Application No. 10/579,444  
Amendment dated June 16, 2008  
Reply to Office Action of March 27, 2008

**Amendments to the Drawings:**

REMARKS/ARGUMENTS

**FIG. 9.**

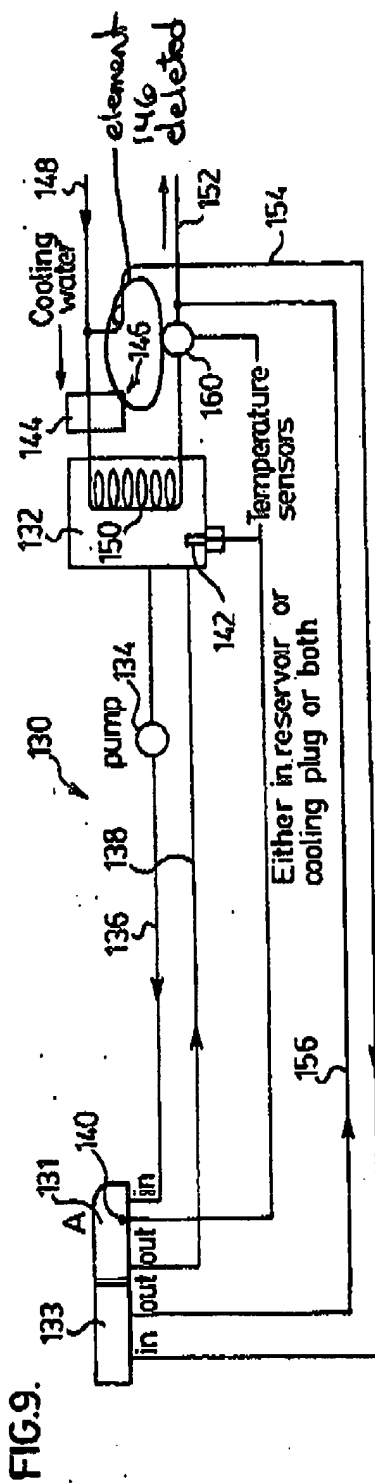
The attached sheet of drawings includes changes to Figure 9. This sheet, which includes Figures 8-11, replaces the original sheet including Figures 8-11. In Figure 9, element 146 has been deleted.

With respect to the drawings, reference character 146 has been deleted from Figure 9 and reference character 112 has been added to the description. The replacement paragraph at line 30 on page 15 has now been corrected. Claims 1, 2 and 4 were rejected under 35 U.S.C. 103(a) as being unpatentable over Lupke et al. US Patent 4,510,013 in view of Chan US Patent 4,789,327.
